Jonesboro Tank Painting Project		
ADDENDUM # 1		
DATE	Wednesday, April 26, 2023	
RFB NUMBER	2023-WP-11	
RFB OPENING DATE	Tuesday, May 2, 2023 at 2:00 p.m. local time

Jonesboro Tank Painting Project

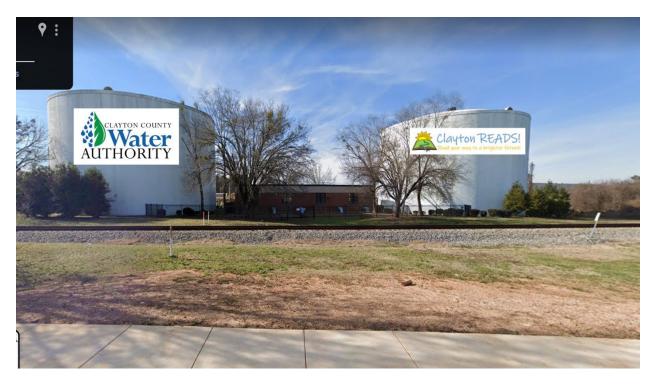
19) Will the CCWA logo on each tank only be put on one side?

Answer: CCWA requires one (1) logo per tank only. See below illustration:
